Access Compliance Report

Public Rights-of-Way

(Curb Ramps)

Intersection ID: 47279	Main Street: SAVANNAH_HILLS_DR	Cross Street: CARRINGTON_FOREST_LN	Location: E
ADA ID: CC5FA5715D96	Ramp Type: PerpDiag	Initial Pass/Fail: Fail	Overall Compliance: No
		Severity Score: 12.5

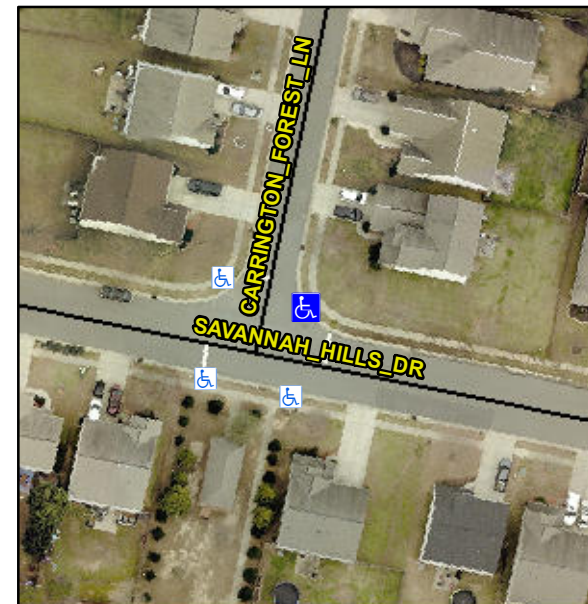
R304.2.2

Compliance	Description	Data	Compliance	Description	Data
N/A	Ramp Length (in)	47.0	No	Ramp Slope (%)	9.4
Yes	Ramp Width (in)	48.0	Yes	Ramp XSlope (%)	1.8
N/A	Flare Type LT	N/A	N/A	Flare Type RT	N/A
N/A	Flare Slope LT (%)	N/A	N/A	Flare Slope RT (%)	N/A
N/A	Flare Traversable LT?	N/A	N/A	Flare Traversable RT?	N/A
N/A	Landing Length (in)	N/A	N/A	DWS Provided?	N/A
N/A	Landing Width (in)	N/A	N/A	DWS Contrast?	N/A
N/A	Landing Slope (%)	N/A	N/A	DWS Length (in)	N/A
N/A	Landing X Slope (%)	N/A	N/A	DWS Full Width?	N/A
N/A	Landing Curb? (Y/N)	N/A	N/A	DWS Offset (in)	N/A
N/A	Shared Landing?	N/A			
N/A	Gutter Ponding?	N/A	N/A	Gutter Slope (%)	N/A
N/A	Gutter Lip Ht (in)	N/A	N/A	Gutter X Slope (%)	N/A
N/A	Painted X Walk1?	No	N/A	Painted X Walk2?	No
	X Walk 1 Direction	To NW		X Walk 2 Direction	To SW
N/A	X Walk 1 Width (in)	N/A	N/A	X Walk 2 Width (in)	N/A
	X Walk 1 Slope (%)	3.5		X Walk 2 Slope (%)	4.9
	X Walk 1 X Slope (%)	0.9		X Walk 2 X Slope (%)	4.4

Remove & Replace Curb Ramp With Two New Directional Ramps or Equivalent.
